# Work Order ID 88744

# DART SERVICE INSTRUCTION

TO AMEND INSTALLATION INSTRUCTIONS IIN-D206-667 REV. C AND EARLIER AND  
INSTRUCTIONS FOR CONTINUED AIRWORTHINESS ICA-D206-667 REV. 2 AND EARLIER

# Non-Conformance Report

**FIGURE 1 - GROUNDING STRAP INSTALLATION**  
(VIEW LOOKING FWD)

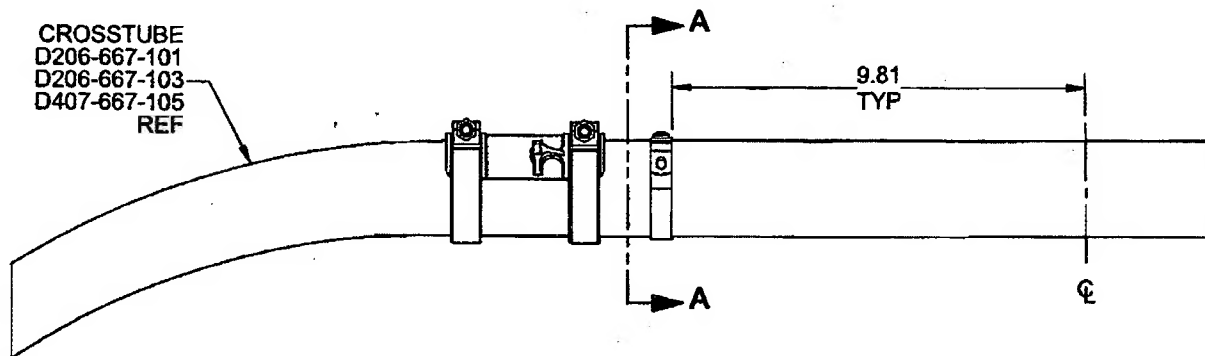
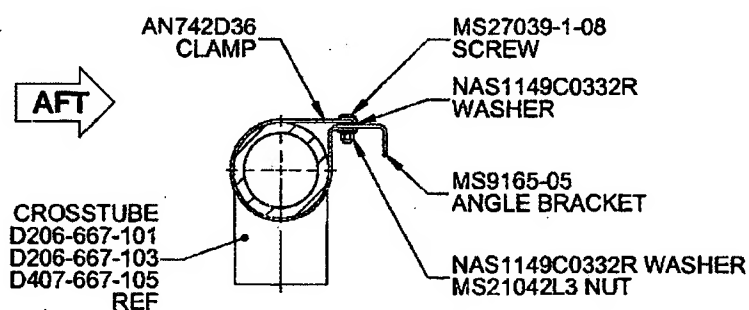
The purpose of this service instruction is to add the optional D206-667-017 Kit and provide guidelines to install extra clamps on D206-667-101/-103 or D407-667-105 forward crosstubes to allow fastening of OEM grounding straps.

- 1) If installed, follow Section 32.1 of ICA-D206-667 for removal of the forward crosstube from the helicopter.
- 2) Locate AN742D36 Clamp as shown in Figure 1 of this service instruction and mark location of clamp on the crosstube.

- 4) Install AN742D36 Clamp complete with MS9165-05 per Section A-A of Figure 1 of this service instruction.
- 5) Touch up paint as required per Item 5.3.3 of ICA-D206-667.
